Bob's Clam Hut - Column Capacity 109 Cumberland Ave Portland, ME

Structural Integrity job number: 18-0107

Bob's Clam Hut		Roman Shades & String Lights		CK 04
109 Cumberland Avenue, Portland, Maine	Drawing Size: 11" X 17"	Scale: As Noted	30 May 2018	3N-04

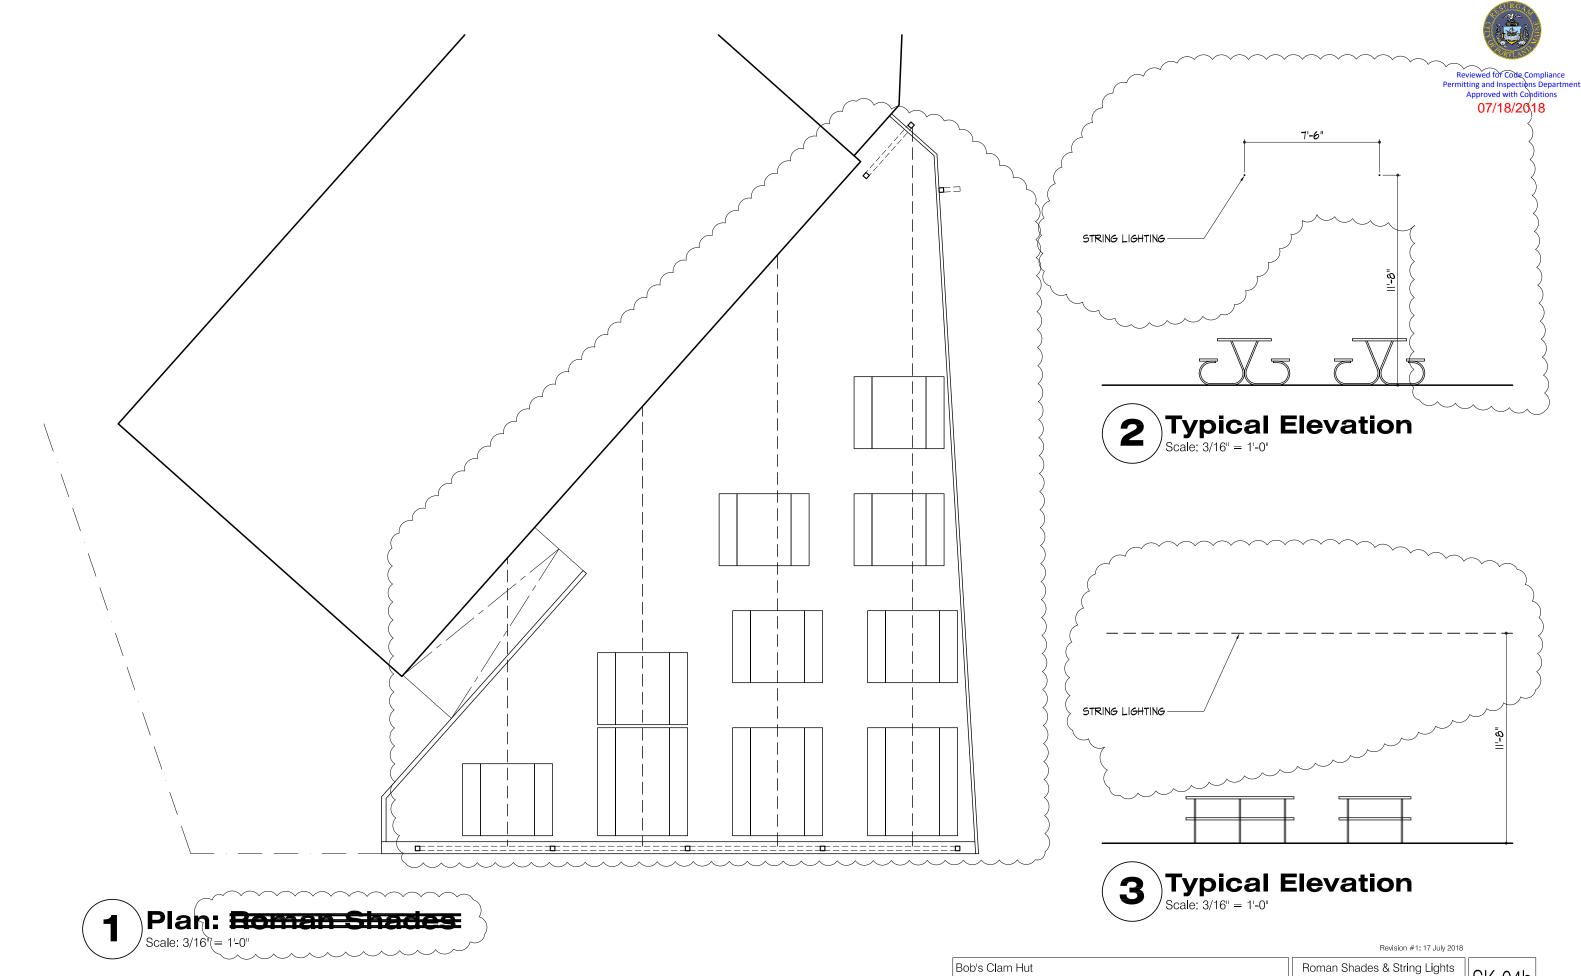
As requested, I am writing you this letter regarding the capacity of the structure supporting the string lights installed at the above referenced location. The opinions and comments included in this letter are based on a visit to the site, review of the revised drawings SK-04 Rev-1 and SK-07 Rev-1 prepared by Paul Bennett Architects dated 17 July 2018 and our analysis of the structure. We have reviewed the cable capacity and anchorage as well as the column capacity and attachment to the foundation.

Based on our analysis, review of the drawings and observations on site we have determined that the system currently in place can adequately support the loads imposed by the lights in accordance with IBC.
